Deviation From Design

DfD : **DfD-0017**

**Taran Laval – SAAA Builder 7417
Van's Aircraft RV7 - 73918**

LH ELEVATOR RIVET CHANGE

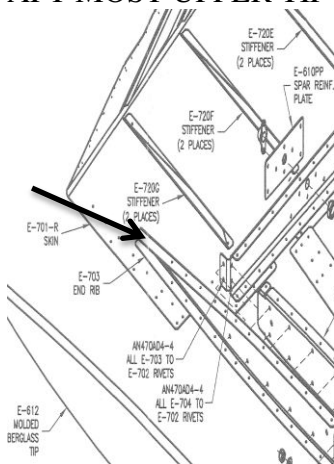
AFT MOST UPPER TIP RIB HOLES INACCESSABLE FOR RIVETING

INSTALLED MK-319-BS BLIND RIVET IN TWO LOCATIONS
